ALERT SERVICE BULLETIN

Checking of the correct positioning of sealing plug in ignition housing for ROTAX® Engine Type 912 i (Series)

ATA System: 24-20-00 Internal generator

Fig. 3
Correcting the sealing plug position with special tool (insertion jig)

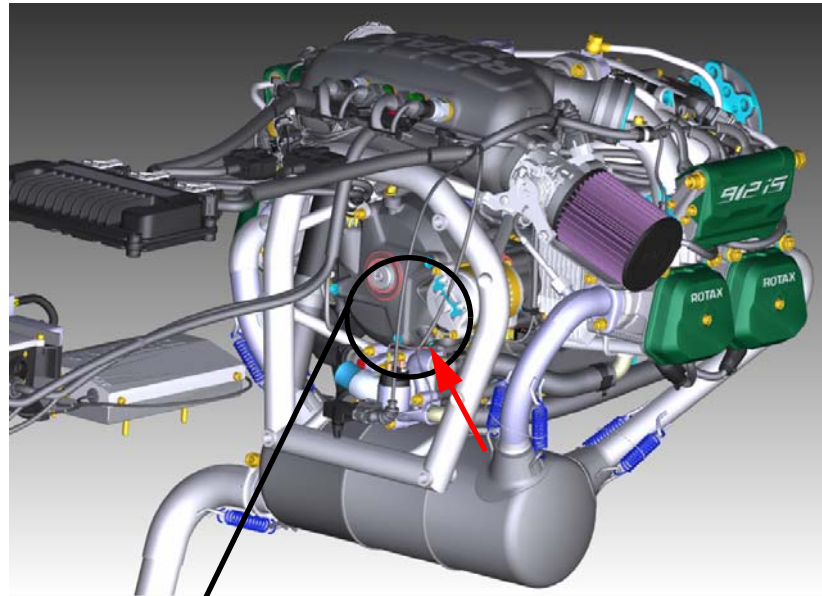
Step	Procedure
1	<p>Correct the sealing plug position with a hammer (max. 300 g / 0.66 lbs) and the relevant insertion jig part no. 676255 as per section 2.6. Intuitively control your manual insertion force just to set the ball in correct position. See Fig. 3.</p> <p>NOTE: The bore must be free of oil, grease and chips.</p> <p>NOTE: Make sure to insert the insertion jig in correct alignment of the center bore / center line of the sealing plug.</p>

Fig. 1
Sealing plug in ignition housing

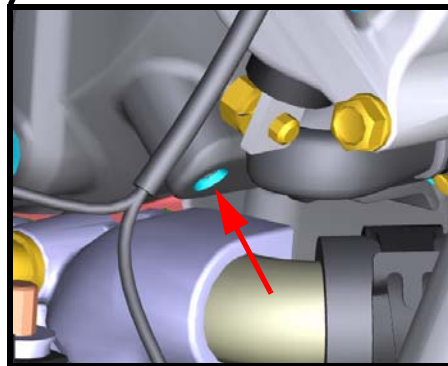
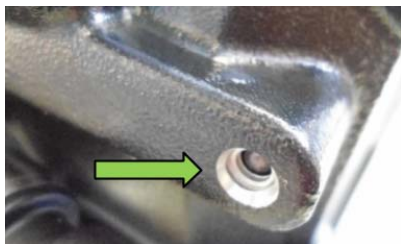
Field observation has shown that in isolated cases the sealing plug (see Fig. 1) was not pressed to its correct seating position in the ignition housing. In rare cases this may lead to loss of oil and subsequently loss of lubrication which leads to engine stoppage.

Fig. 2
Good/bad comparison of sealing plug position

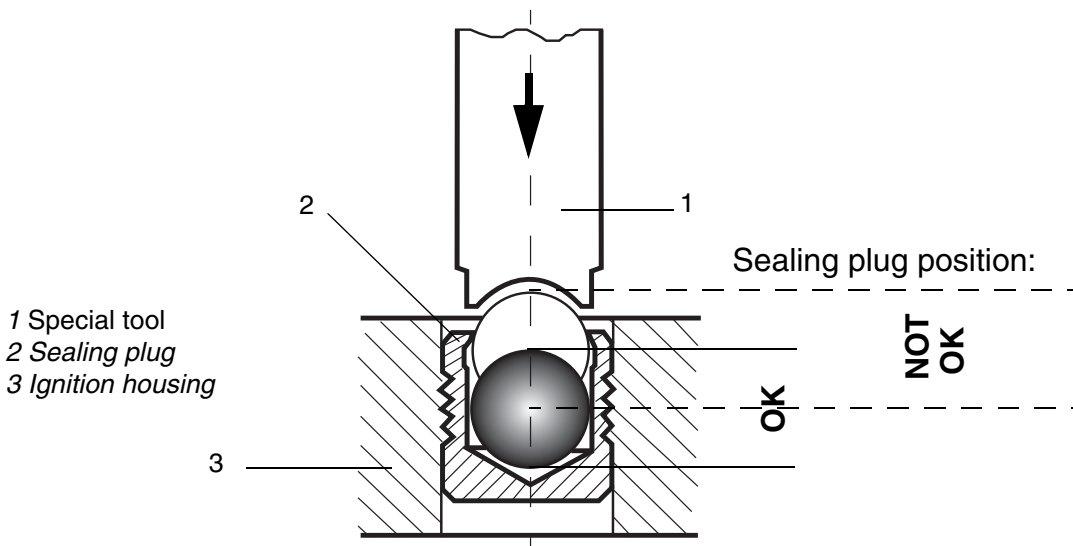
Step	Procedure
1	Check the position of sealing plug in the relevant area of ignition housing assy. See Fig. 2.
2	The sealing plug must show to have been pressed in until the top of the ball is below the edge of the sleeve. See position OK in Fig. 2.
3	If you notice sealing plug position is OK, then there is no need for further procedures. NOTE: If you notice sealing plug position is NOT OK, then see section 3.2.

3.2) Correcting sealing plug position (required if position of sealing plug is incorrect, see Fig. 2)
